Texas Commission on Environmental Quality

Facility Name: City of Del Rio Landfill

Permit or Registration No.: MSW 207C

Re: Response to Technical Notice of Deficiency (NOD)
City of Del Rio
Del Rio, Val Verde County, Texas
Proposed Municipal Solid Waste Permit No: 207C
Tracking No. 29656107; RN102143294/CN600756290
Permit Major Amendment Application

FIGURE
I/IIA.1

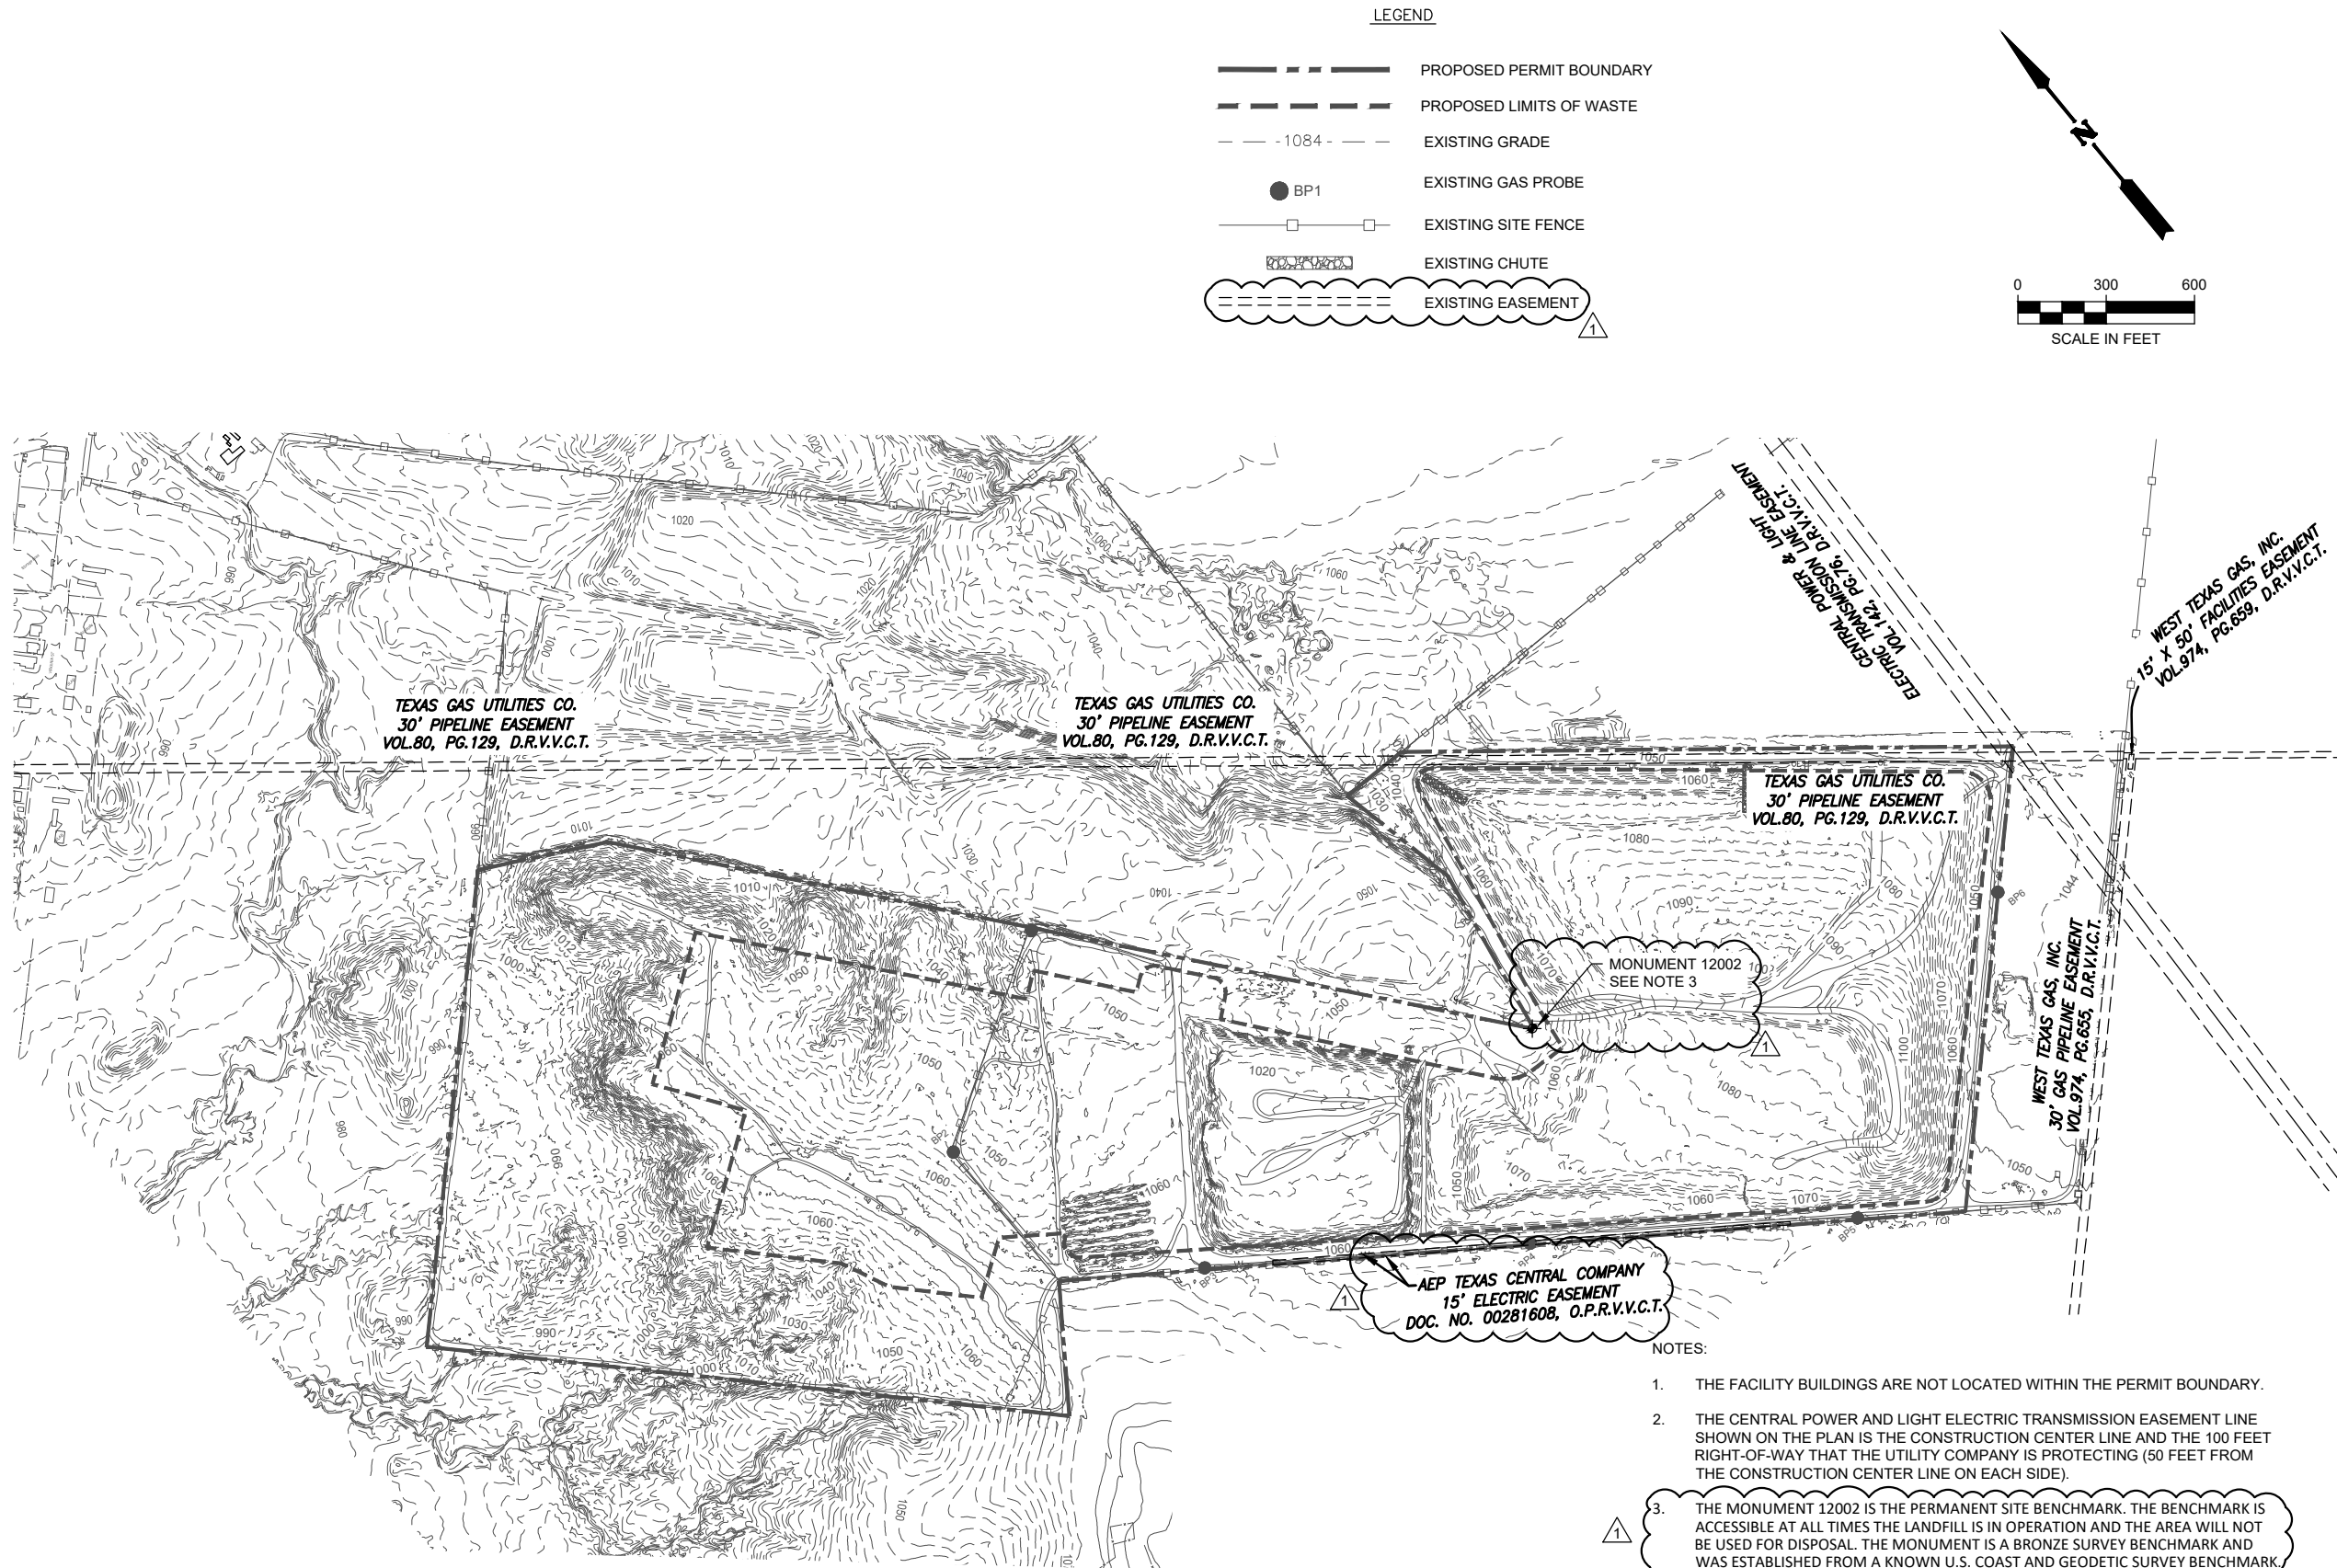
T26	180	Part II	330.61(c)(10)	Appendix I/IIA	Ambiguous	<p>Comment: Regarding Figure I/IIA.1:</p> <ul style="list-style-type: none"> a. Revise to provide legends for easements or revise to refer to where relevant easement information is contained. b. Revise to clearly show the electric easement limits at the southwest perimeter of Cell 5. (refer to the above comment) <p>Response:</p> <ul style="list-style-type: none"> a) The easement line has been added to the legend. b) The drawing has been revised to clearly show the 15-foot electrical easement limits near Cell 5.

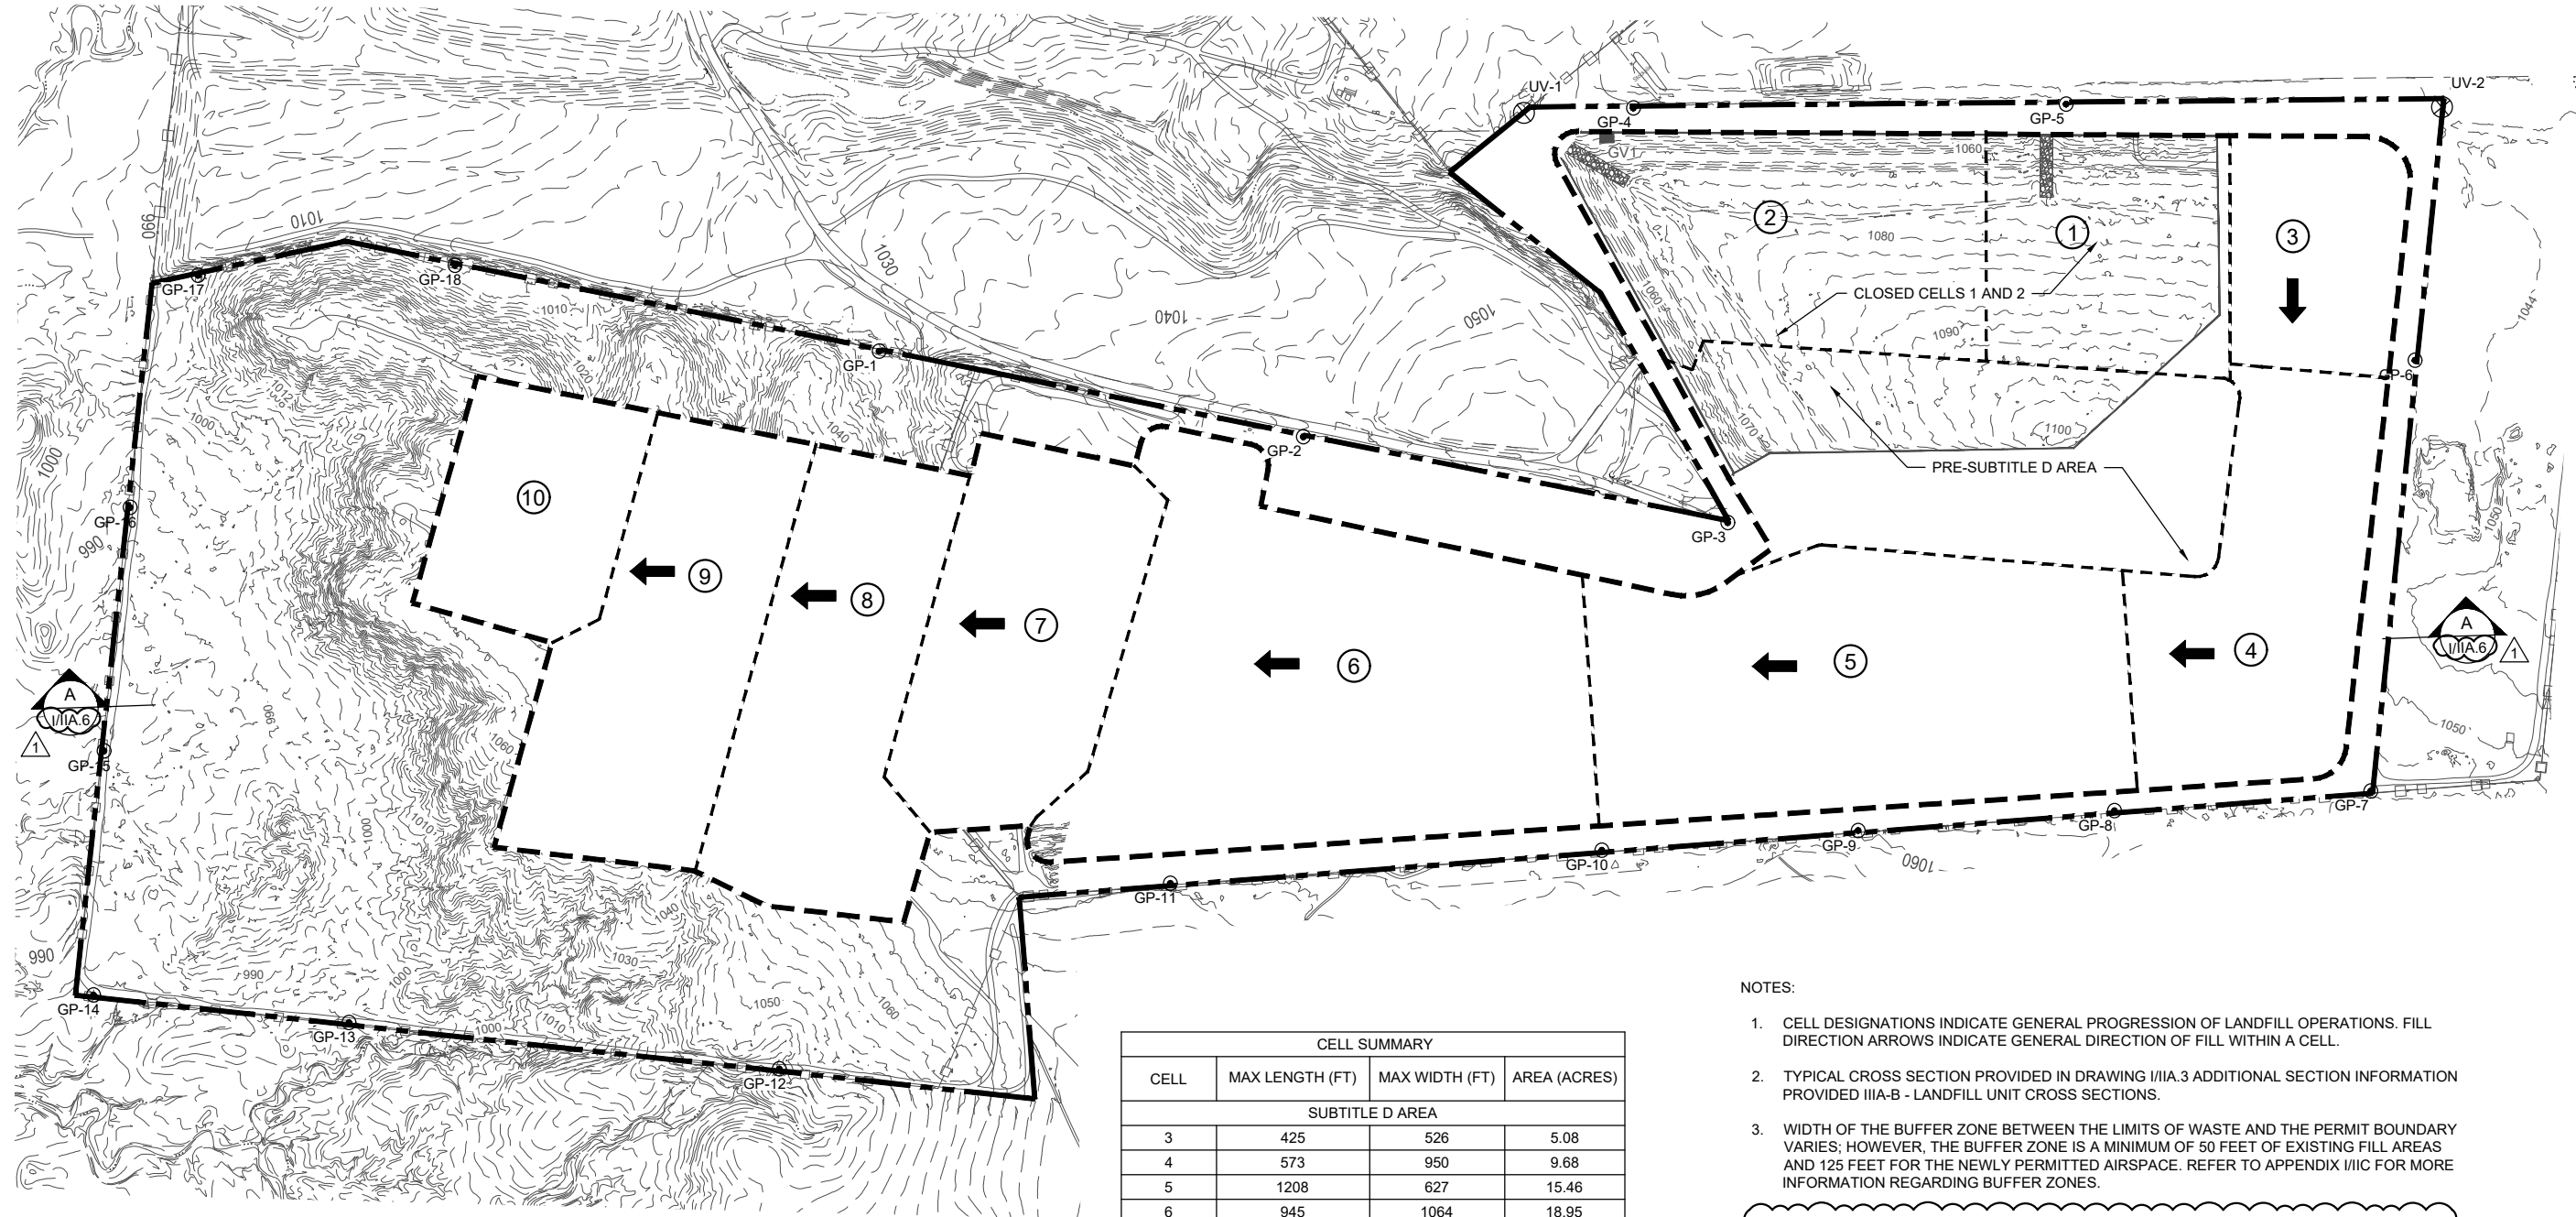
ID	App. Part	App. Section	Location	Citation	Error Type	Deficiency Description/Resolution
T9	25	General	330.57(h)(1)	All drawings	Inconsistent	Comment: Revise Figure I/IIA.2 to provide correct cross-section reference index. Response: The cross-section reference has been updated on I/IIA.2.
T10	27	General	330.57(h)(3)	All drawings	Inconsistent	Comment: a) Revise Figure I/IIA.3 to ensure use of correct cut/fill markers. Revise all relevant drawings in the application to ensure that correct cut/fill markers are used (for example, but not limited to, Figures IIIA-B.2 and IIIC-3.1). It is noted that Figure I/II-2.2 shows a legend for cut/fill markers. b) Revise the table of contents for Appendix IIIC to include Figure IIIC-3.1 Leachate Collection System Plan. Response: a) Figures I/II2.2, I/IIA.3, IIIA-B.2, and IIIC-3.1 have been updated to show the correct cut/fill markers. In addition, the permitted leachate system has been added to these drawings. b) The Table of Contents for Appendix IIIC has been updated to include Figure IIIC-3.1 (page IIIC-11)

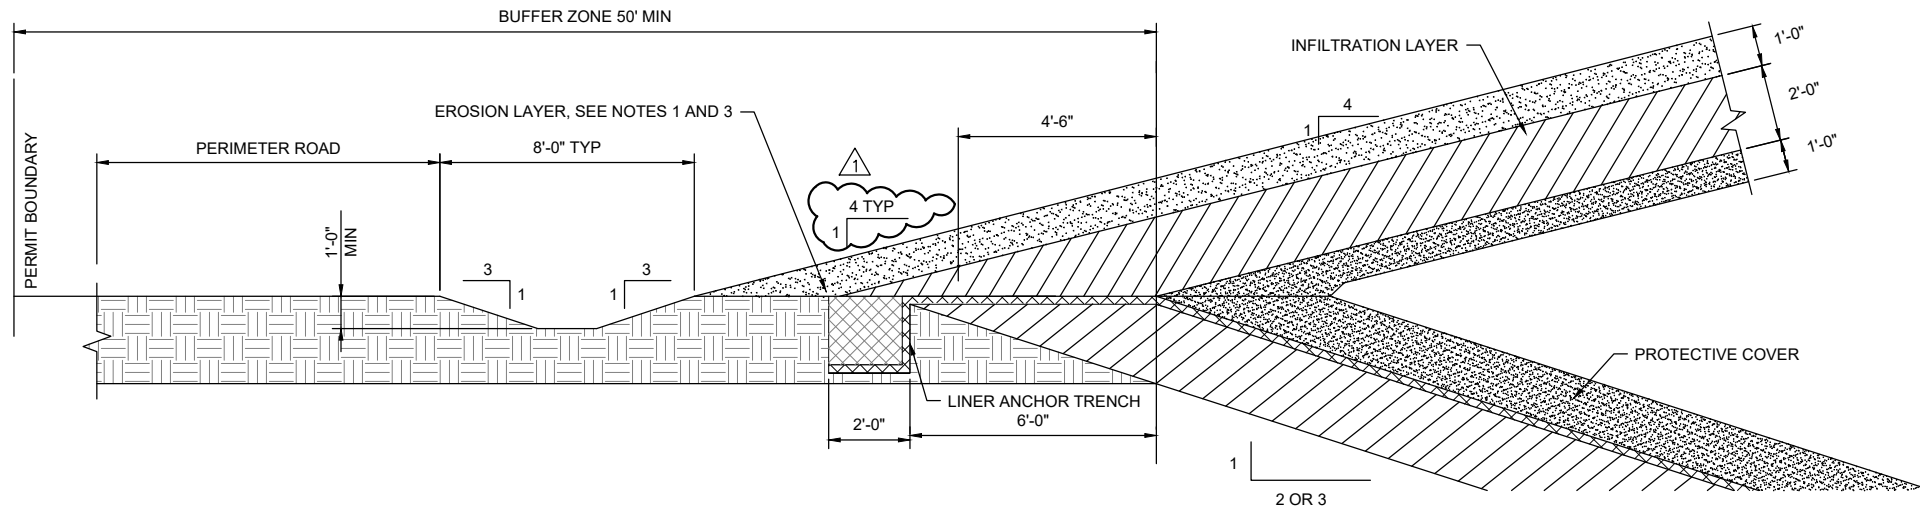
ID	App. Part	App. Section	Location	Citation	Error Type	Deficiency Description/Resolution
T54	738	Part III	330.457(a)	Appendix IIIE	Incomplete	<p>Comment: The following comments are related to final cover design discussed in Section 4.3 of Part III, Site Development Plan.</p> <ul style="list-style-type: none"> a. Revise Section 4.3 to clarify if the final cover designs specified in Table 4-3 are the designs approved in MSW 207B. b. Revise Section 4.3 to clarify if the final cover installed in the closed areas is of the same design specified in Table 4-3. c. The final cover designs listed in Table 4-3 are different than those specified in Table 4-1 of Appendix IIIA; explain the differences or revise for correctness and consistency. Infiltration layer hydraulic conductivity specified in Appendix IIIA, Table 4-1 is also different than Figure IIIA-A.6; explain or revise, as necessary. d. Revise Section 4.3 to specify a final cover system consistent with 330.457(a)(1) for proposed new cells and developed cells/area where the liner includes a geomembrane component (refer to comments on MRI ID 359). Revise all relevant portions of the application (text and drawings) as necessary (including, but not limited to, Appendix IIIA, Appendix IIIG). e. Revise Section 4.3 to provide design and installation requirements (text and drawings) for the transition between two different final covers (refer to the above comment). Revise all relevant portions of the application (text and drawings) as necessary (including, but not limited to, Appendix IIIA, Appendix IIIG). f. The final cover slope at the toe is shown to be 3:1 TYP in Figure IIIA-A.7, while the final cover slopes are specified and illustrated to be 4:1 (e.g., Figure IIIA-A.6). Explain the discrepancy or revise as necessary. <p>Response:</p> <ul style="list-style-type: none"> a) Section 4.3 on page III-10 has been revised. b) Section 4.3 has been revised. c) The Table 4-1 in Appendix IIIA (page IIIA-3) has been updated to match Table 4-1 in the SDP narrative (Page III-10) d) The proposed (previously approved Alternate Liner) liner for the new cells does not include a geomembrane component and 330.457(a)(1) does not apply. The proposed final cover is designed in accordance with 330.357(a)(2). e) This is not required as there is no transition between two different final covers as the final cover is consistent throughout f) Drawings IIIA-A.7 has been revised to be consistent with the rest of the application.
